Re: Application to Amend Order SWD-1574
Mesquite SWD, Inc.
Okerlund SWD Well No. 1
API No. 30-025-43535
1470' FSL & 1555' FEL, Unit J
Section 7, T-21S, R-32E, NMPM,
Lea County, New Mexico

Mesquite SWD, Inc. ("Mesquite"), the successor operator of the Okerlund SWD No. 1 respectfully requests that Order SWD-1574 be amended to authorize the use of a 7" x 5 ½" tapered tubing string within the subject well, and to authorize minor changes in the casing program and open-hole interval hole size.

Mesquite SWD, Inc.
Okerlund SWD No. 1: Proposed Wellbore Schematic
1470' FSL & 1555' FEL (Unit J)
Section 7, T-21S, R-32E, NMPM, Lea County, NM

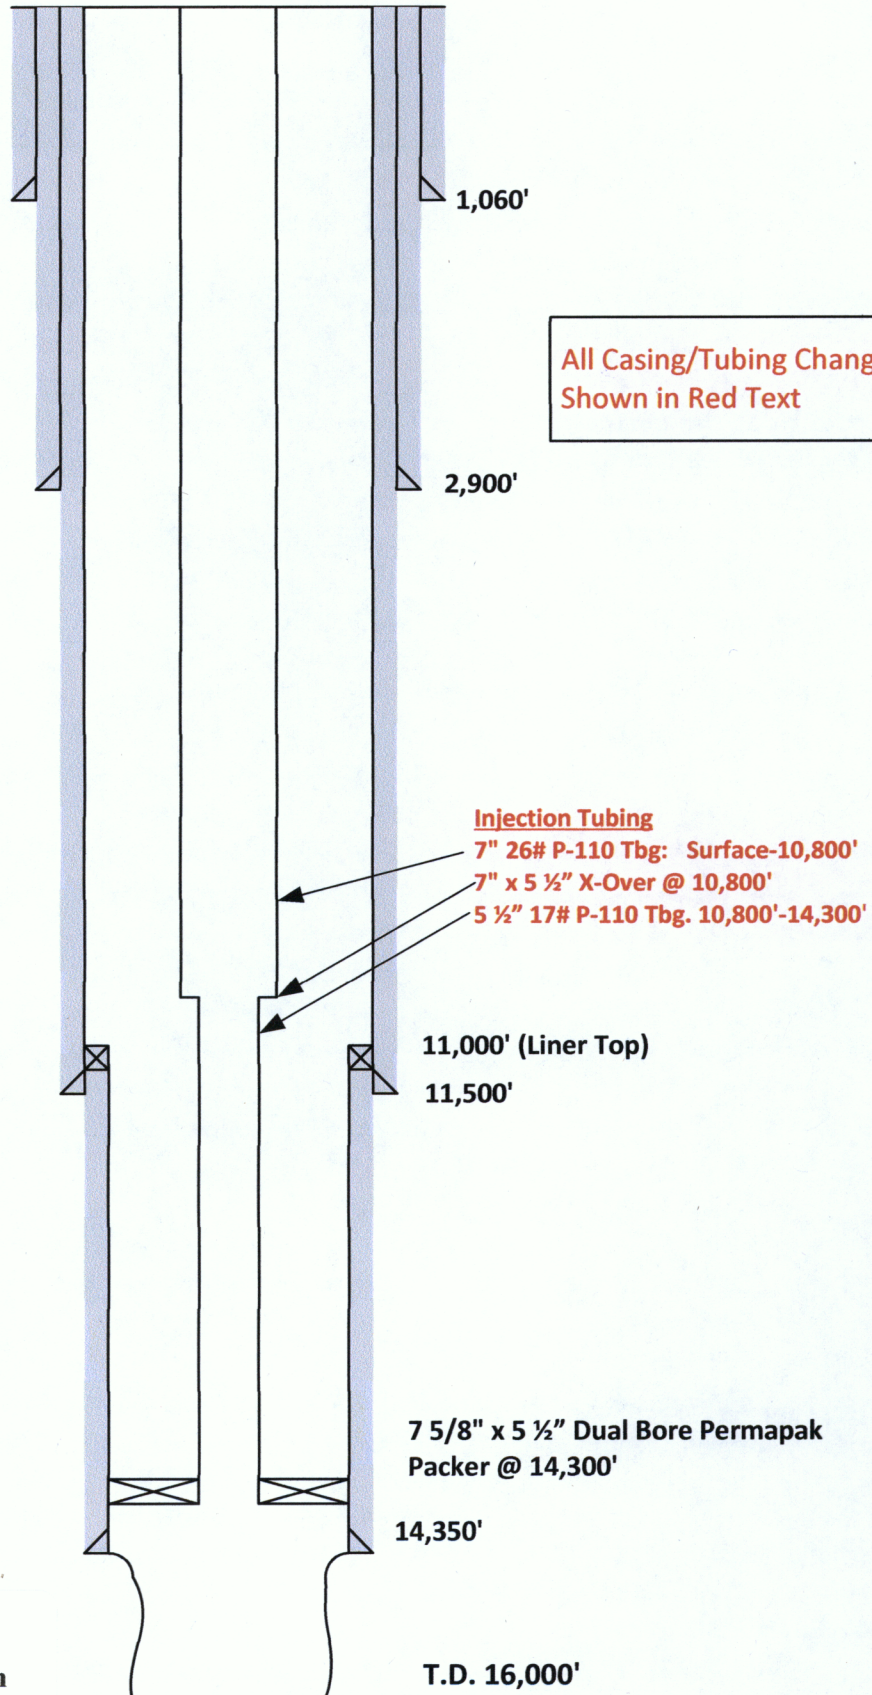
3. Copy of Mesquite's letter to the Division dated June 19, 2018 requesting a second extension of Order SWD-1574 (Exhibit 3);
4. Attached is the originally proposed wellbore configuration as submitted within the C-108 application filed by R360 Permian Basin, LLC on August 3, 2015 that resulted in Order SWD-1574 (Exhibit 4). Also attached is a wellbore schematic that shows the proposed wellbore configuration (Exhibit 5). In addition to the request to amend the tubing size, Mesquite also proposes to make the following changes to the casing program. These changes are highlighted on the attached wellbore schematic and on the BLM and OCD Sundry Notices attached:

<u>Original Casing</u>	<u>Proposed Casing</u>
2 nd Int.	9 5/8" 47# L-80 LTC @ 5,100'	9 5/8" 53.5# P-110 BTC @ 11,500'
Production: Liner	7" 29/35# HCL80/P-110 Surface-14,300'	7 5/8" 39# P-110 FJ Liner 11,000'-14,350'
Open Hole:	5 7/8" Hole 14,300'-16,000'	6 1/2" Hole 14,350'-16,000'
Tubing:	4 1/2" 11.6# L-80 Surface-14,300'	7" 26# P-110; Surface-10,800' 5 1/2" 17# P-110; 10,800'-14,300'

Hole Size: 26"
 Size: 20" 106.4# J-55 LTC
 Set @: 1,060'
 Sx. Cmt: 1375
 TOC: Surface

Hole Size: 17.5"
 Size: 13.375" 68# J-55 LTC
 Set @: 2,900'
 Sx. Cmt: 1940; Staged
 Stage Tool: 1,800'
 TOC: Surface

Hole Size: 12.25"
 Size: 9.625 53.5# P-110 BTC
 Set @: 11,500'
 Sx. Cmt: TBD. Sufficient to Circulate
 TOC: Surface

Hole Size: 8.5"
 Size: 7.625" 39# P-110 FJ
 Set @: 11,000'-14,350'
 Sx. Cmt: TBD. Sufficient to Circulate
 TOC: 11,000' (Liner Top)

Hole Size: 6 1/2"
 Interval: 14,350' - 16,000'

Exhibit No. 7
 Known Pre-Cambrian Faults
 Application to Amend SWD-1574
 Okerlund SWD No. 1

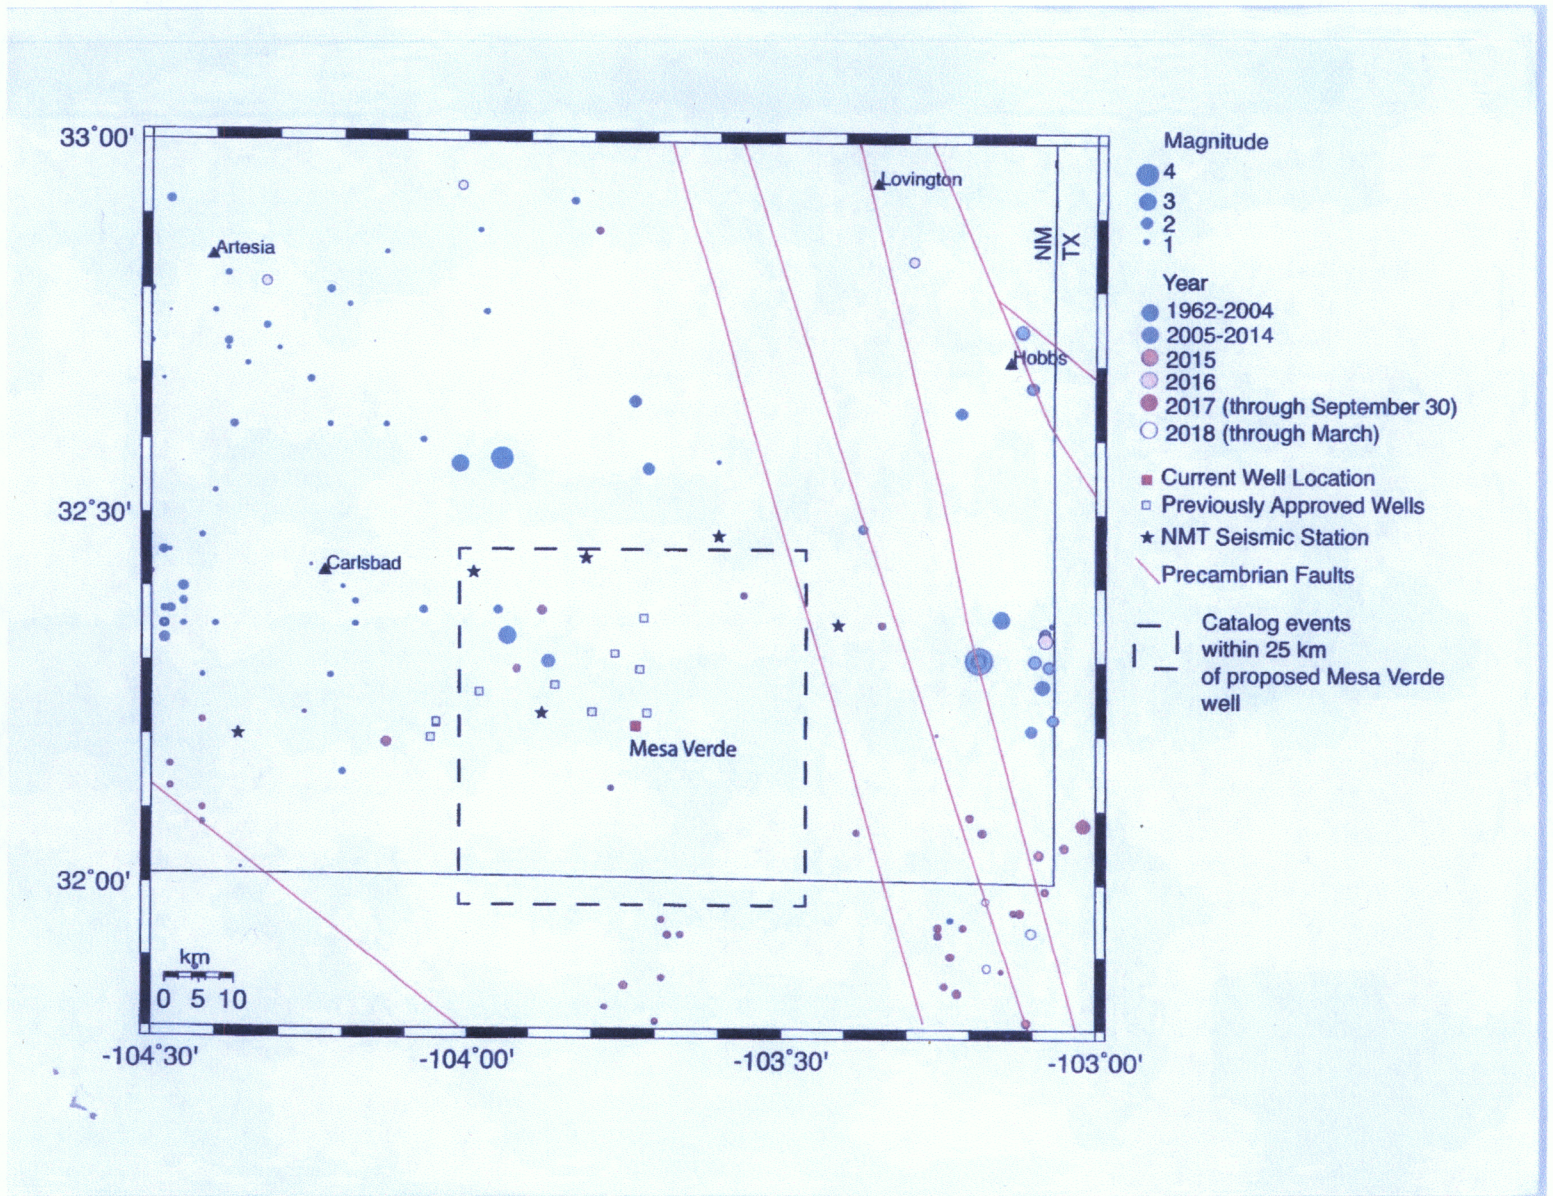
- a. Map of known Pre-Cambrian faults in Southeast New Mexico (Exhibit 7) relative to the location of the Mesa Verde SWD No. 3. (It should be noted that the Okerlund SWD No. 1 is located approximately 20 miles North of the Mesa Verde SWD No. 3 however, both wells are located approximately the same distance away from known Pre-Cambrian Faults);

SandDunes SWD WellboreSize Sensitivity.snp

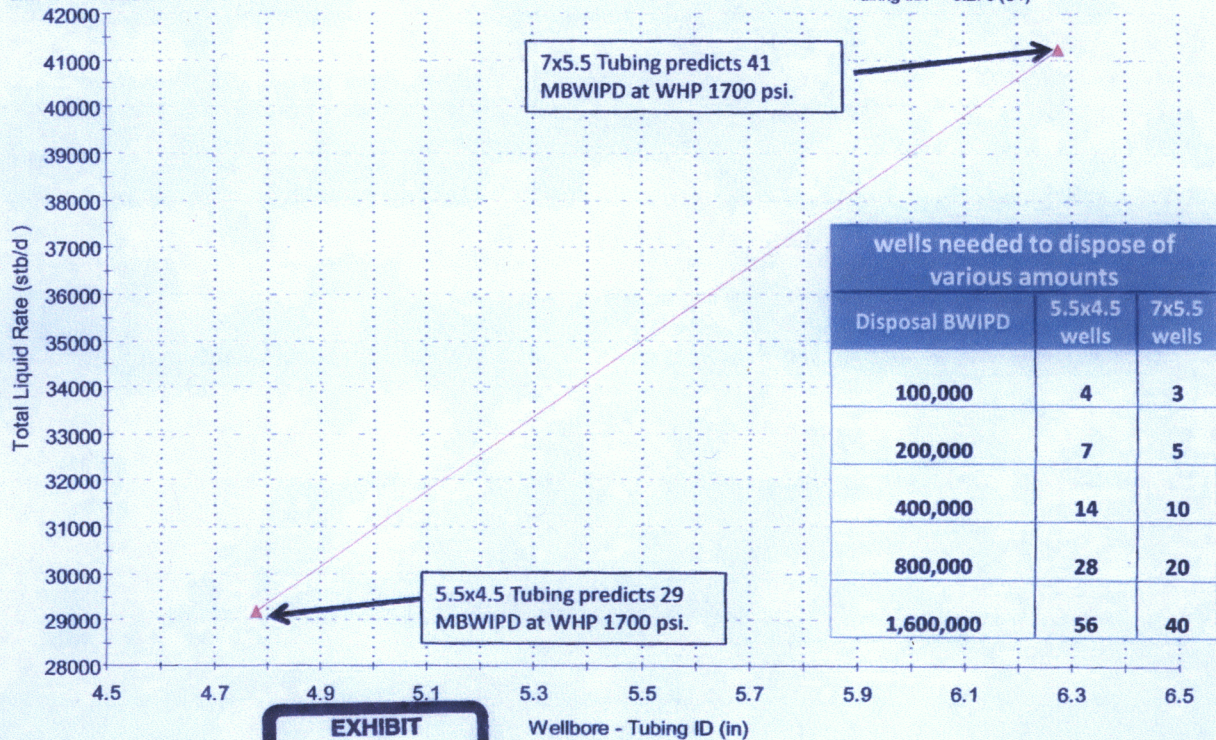
9. Attached is a document presented in Case No. 16308 which demonstrates that increasing the tubing size in a Devonian well in this area will result in an increase in injection rate from 29 MBWPD to 41 MBWPD (Exhibit 9). The resulting increase in

Increased injection rate per well equates to fewer injectors.
